Access Compliance Report

Public Rights-of-Way

(Pedestrian Signals)

Intersection ID: N/A	Main Street:	Cross Street: N/A	Location: N/A
ADA ID: DDEE3F7F483C	Signal Type: One Push Button-Non APS	Overall Compliance: No	Severity Score: BTN 1: N/A BTN 2: N/A No BTN: N/A
Codes/Mitigation Info/Possible Solution		Field Measurements/Component Compliance

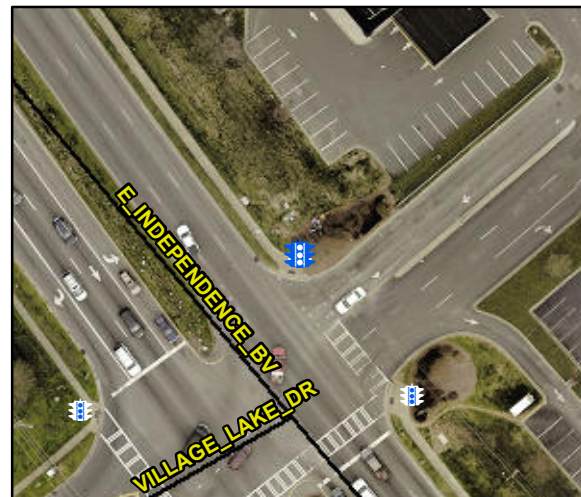
PROW/ADA: TMUTCD 4e.08, R404.2, R404.3, R406.2

Possible Solutions: Replace Signal Push Button With APS Button on New Post. Remove & Relocate Sign.
